THREE MILE ISLAND NUCLEAR STATION, UNIT NO. 1

AMENDMENT TO FACILITY OPERATING LICENSE

Amendment No. 40  
License No. DPR-50

ATTACHMENT TO LICENSE AMENDMENT NO. 40

Figure 2.3-2

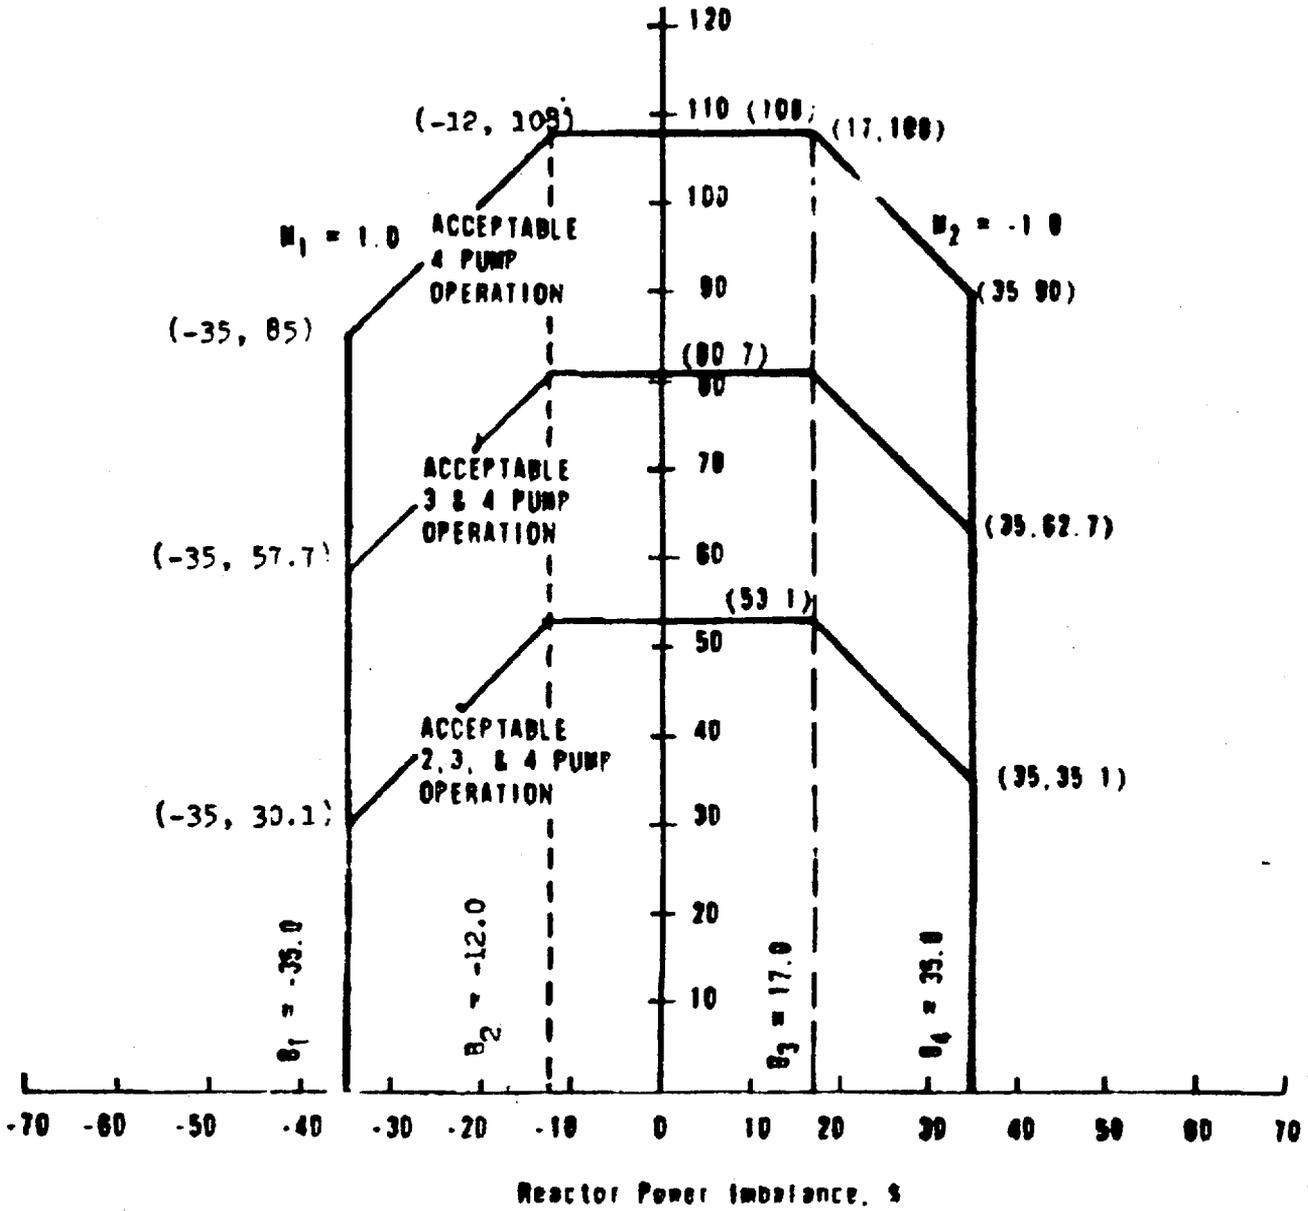
<u>Remove Pages</u>	<u>Insert Pages</u>
Figure 2.3-2	Figure 2.3-2
3-34 & 3-34a	3-34 & 3-34a
3-36	3-36
Figure 3.5-2E	Figure 3.5-2E
Figure 3.5-2H	Figure 3.5-2H

The changed areas on the revised pages are shown by marginal lines.
